ADDENDUM NUMBER 2

**Fiore Residence
41 Hillside Avenue
Milford, Connecticut**

Project Number 1214

19th of May 2015

Sheet Number:
A2

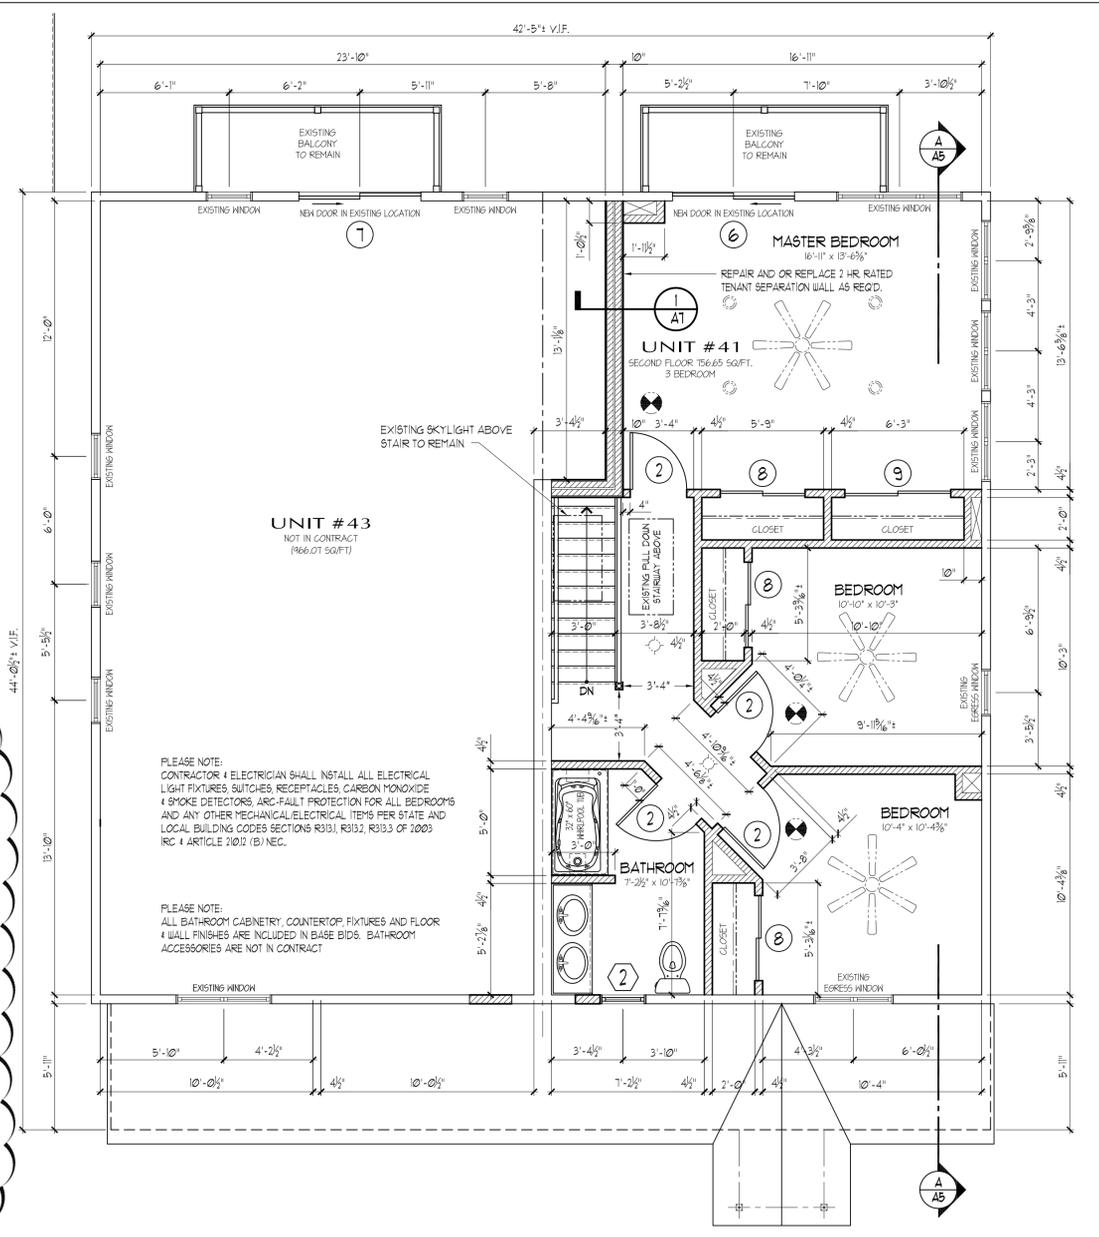
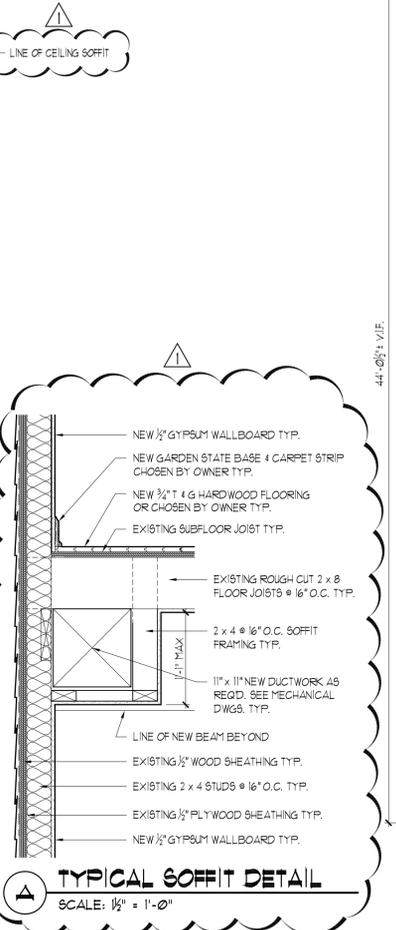
5	Drawing A2	Add: Mechanical Soffit – See Detail A, Typical Soffit Detail on Drawing Sheet A2. The soffit is required to enclose the Mechanical Supply Drops and related Ductwork for the First Floor Spaces. The soffit runs along the south and east (outside) walls.

6	Drawing A2	Clarification: Duct Drop Locations – There are Mechanical Supply Drops in three locations through the Second Floor Spaces. These drops are required to supply heating and cooling to the First Floor. Note the three locations on the Drawings. The supply drops through the Second Floor Spaces will require an enclosure as indicated on the Drawings.
7	Drawing M-1/M-2	Modify: Duct Drop Locations – The location and/or run for the required Ductwork to service the Supply Drop locations has been slightly modified to accommodate the proposed drop locations. Refer to the Mechanical Drawings for additional information.
8	Drawing M-1/M-2	Modify: Kitchen Exhaust Vent Ductwork – The location and length of Ductwork for the Kitchen Exhaust Fan has been modified. The exhaust vent has been modified to run in a westerly direction and to terminate on the low roof above the entrance for Unit 41.
9	Drawing M-2/E-1	Clarification: Air-Conditioning System – The Air-Conditioning System indicated on the Drawings as an Alternate shall be included in the Base Bid Package. The Air-Conditioning System is NOT an Alternate. Pricing shall include all related and required equipment, piping, condenser, wiring and any related components required for operation.
